ADDENDUM NO. 02
TO THE CONSTRUCTION DOCUMENTS BID PACKAGE

Client: Arrowhead Regional Medical Center
Project: Oncology-Ambulatory Clinic
SHA Project No.: 18242.100
Date: September 12, 2019

A3 SECOND FLOOR DEMOLITION PLAN

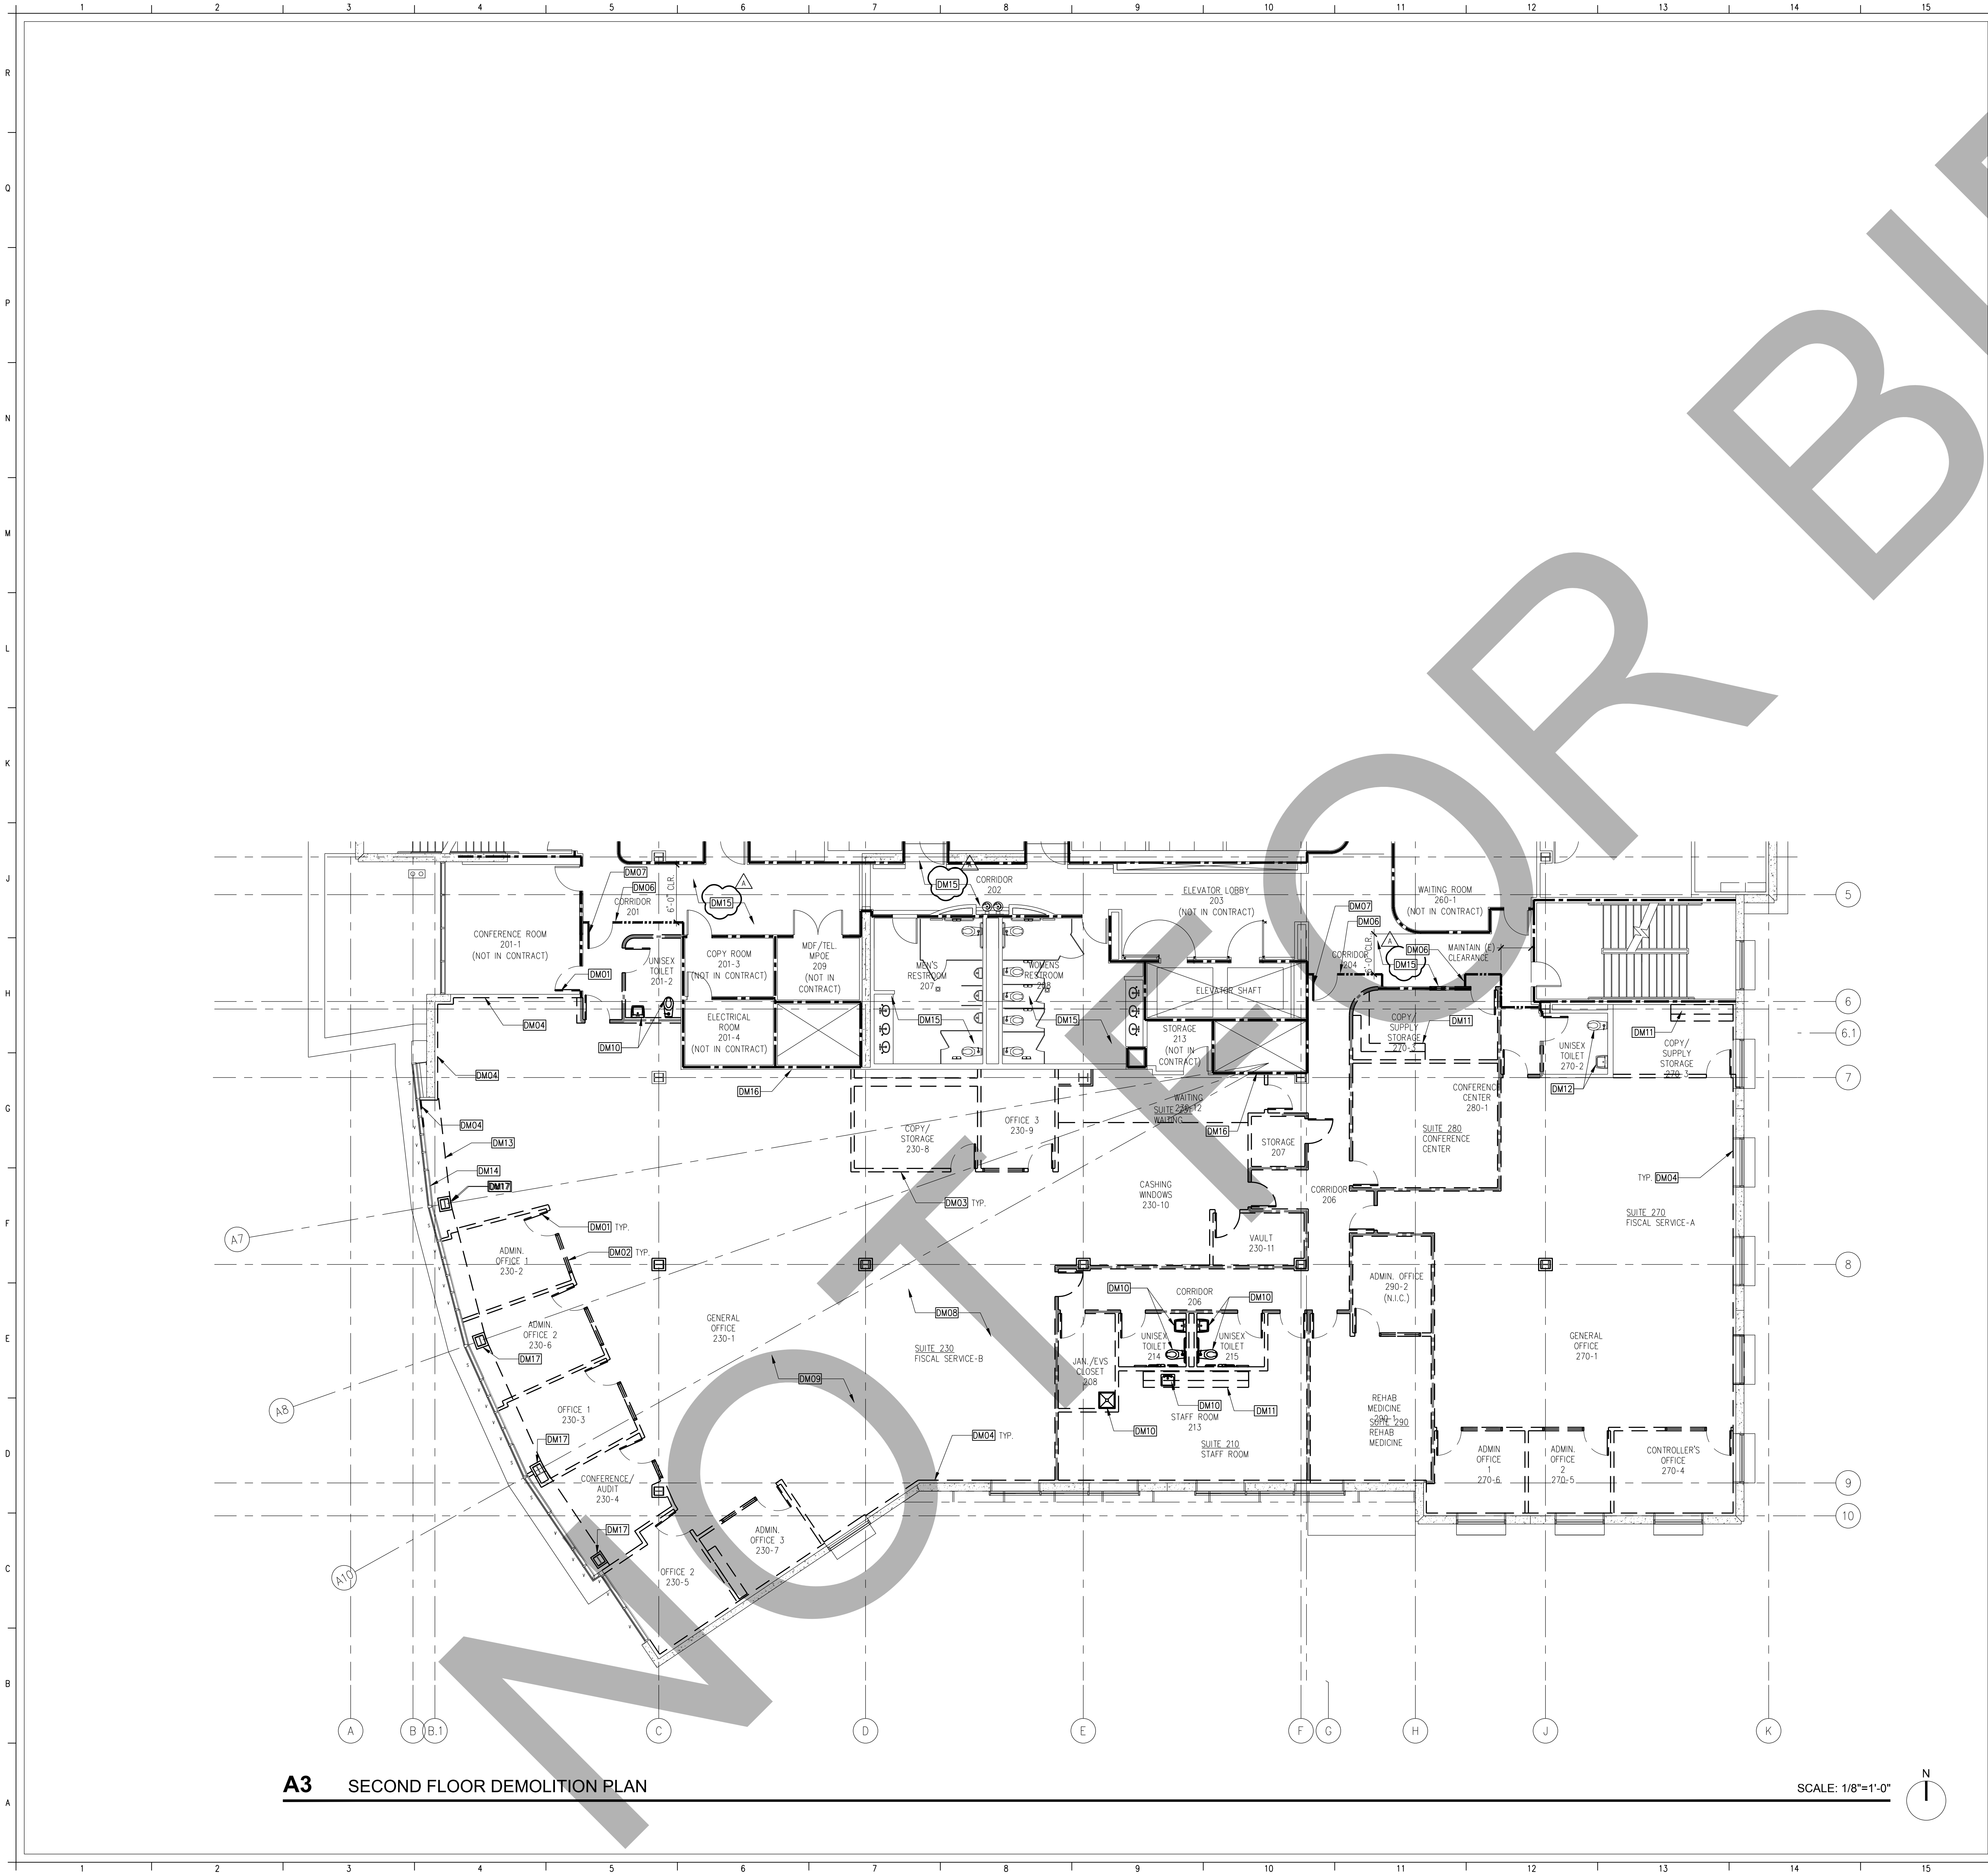
A111 Existing room names added to the corridor that is to the north of the project area, scope revised to indicate partial demolition of the ceiling in this corridor.

General Note added to sheet regarding accommodations for equipment or material deliveries and trash removal from the project area.

002.5	Sheet A111 DM15 shows removal of ceiling in restrooms 207 & 208. Sheet M122 shows these areas as "not in contract". Please confirm these areas are in the scope of work.	Keynote DM15 indicates to DEMOLISH EXISTING CEILING AS REQUIRED BY NEW MECHANICAL WORK ONLY. Coordinate with scope shown on Mechanical drawings. M122 should NOT indicate "NOT IN SCOPE". See revised Mechanical sheets attached.

A3 OVERALL SECOND FLOOR PALN

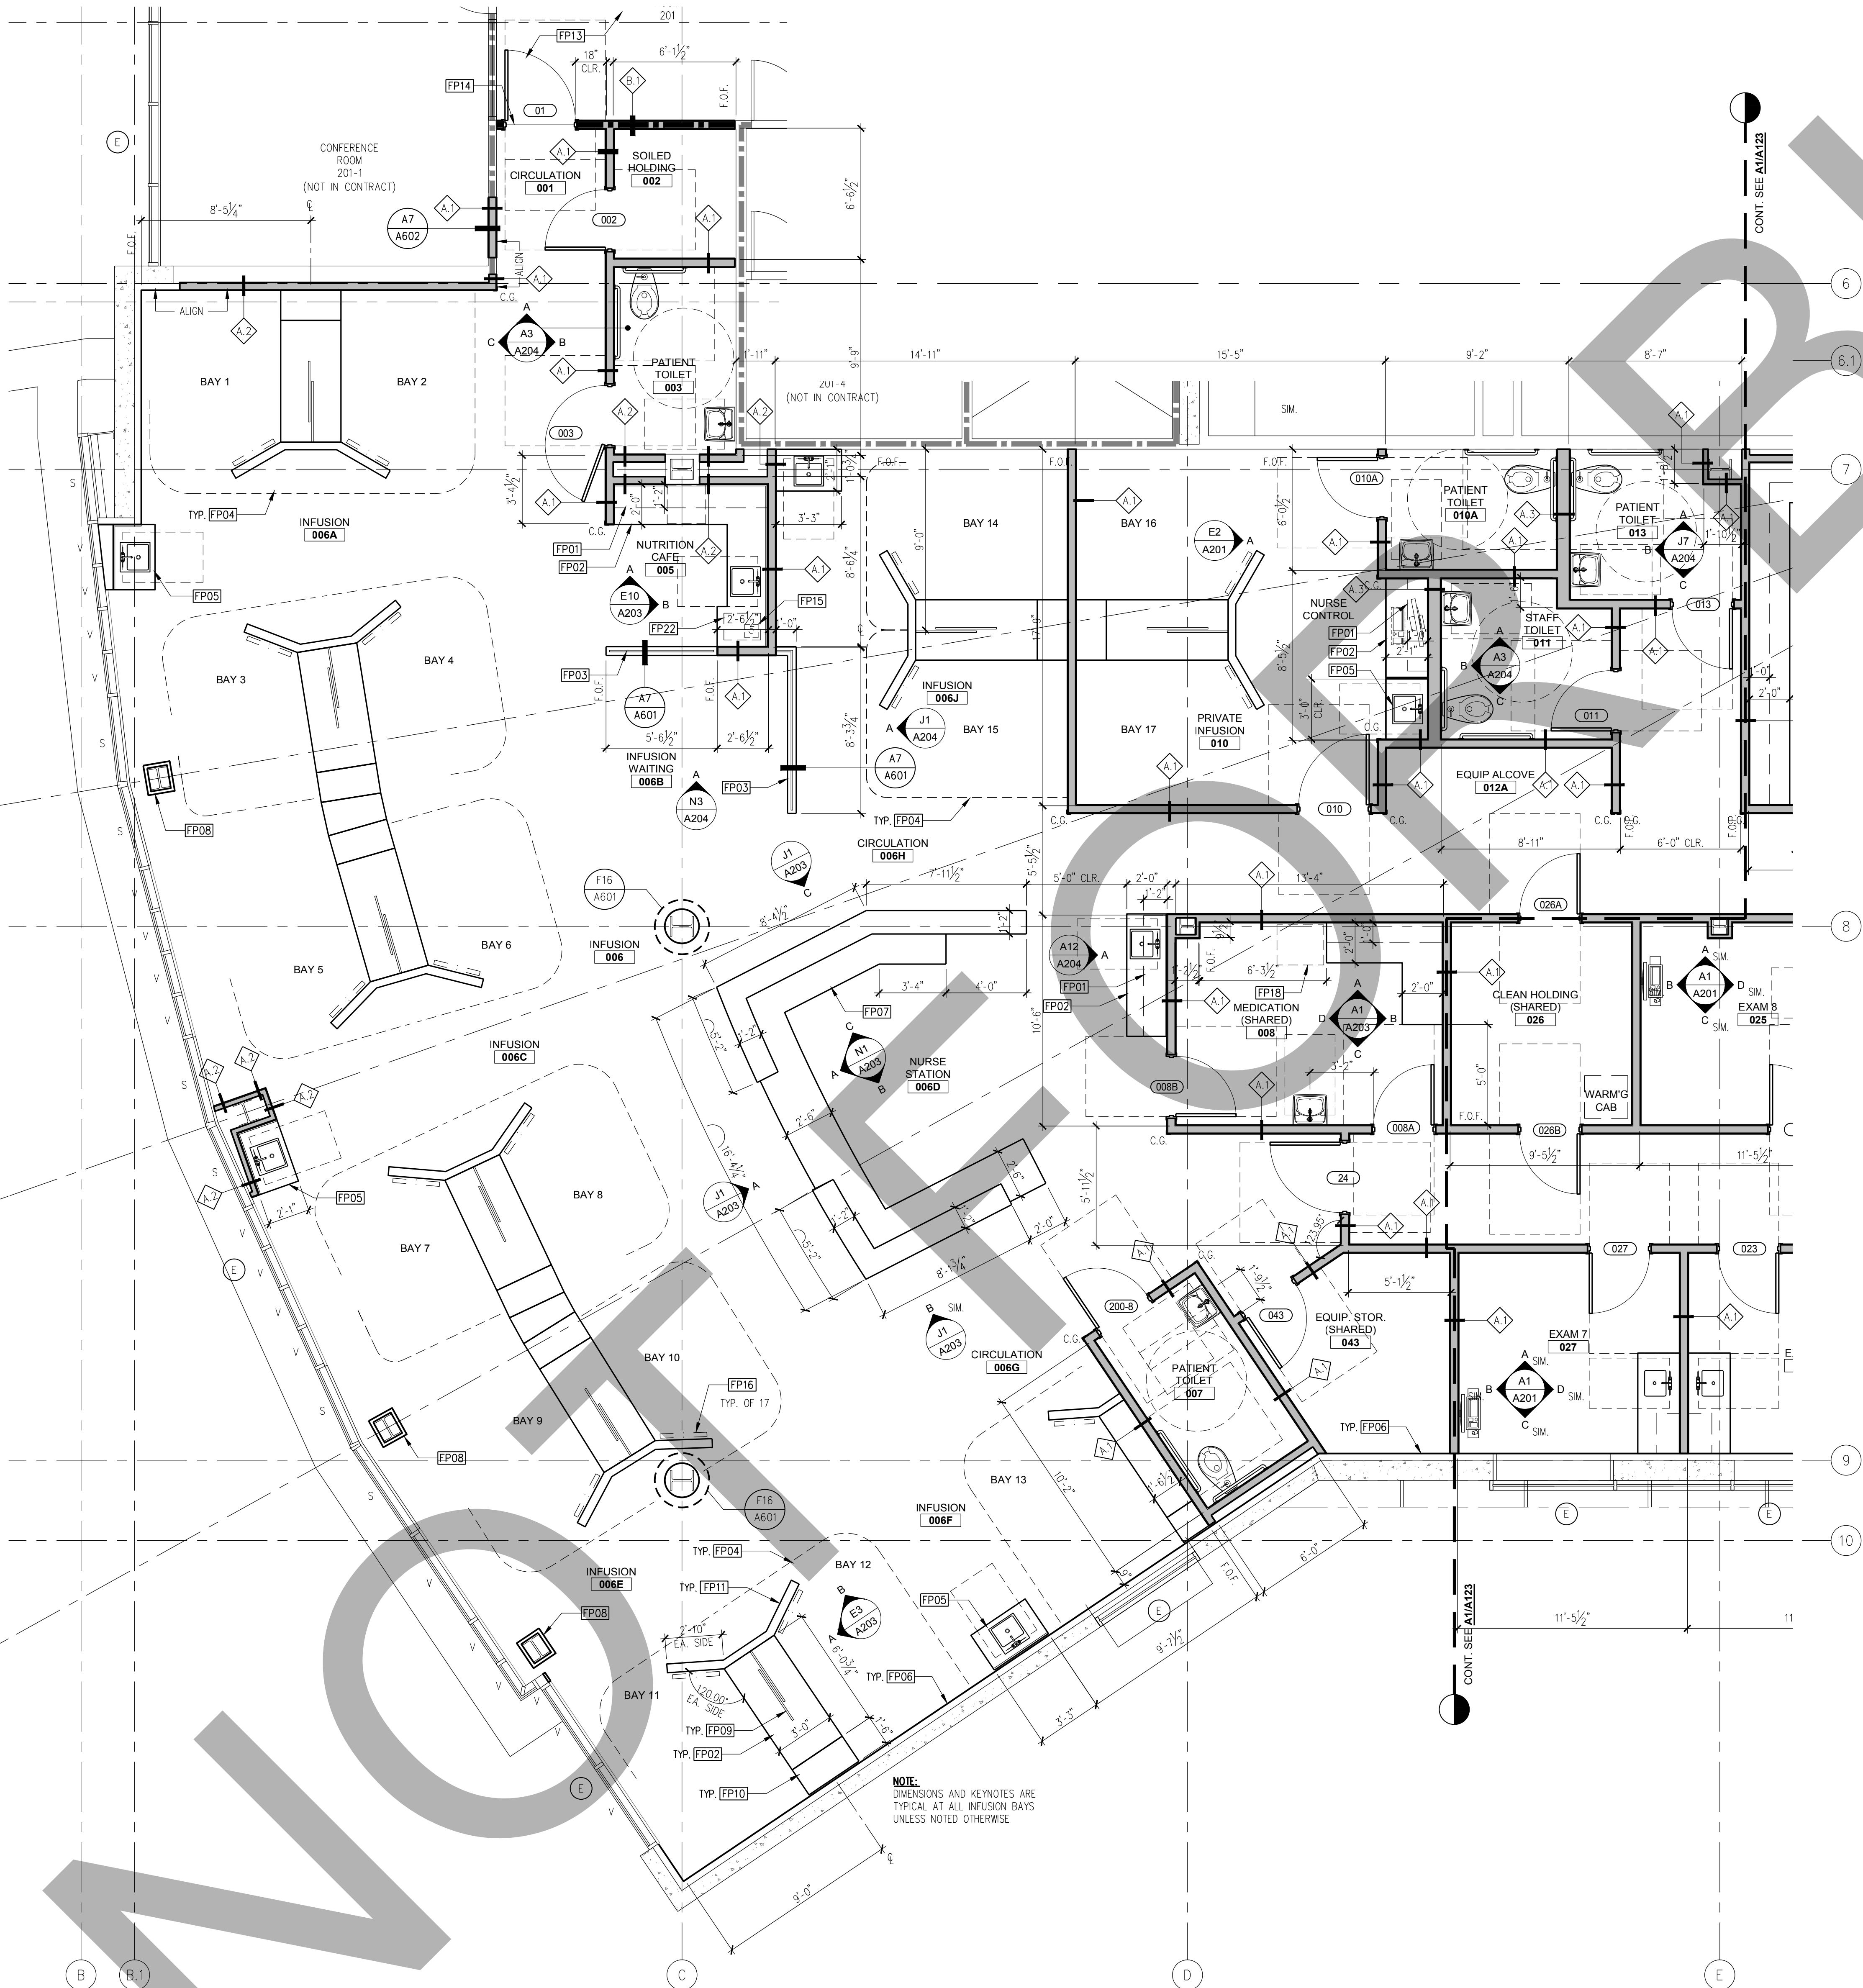
A121 Removed "NOT IN CONTRACT" from room identification tags in rooms that require partial ceiling demolition.
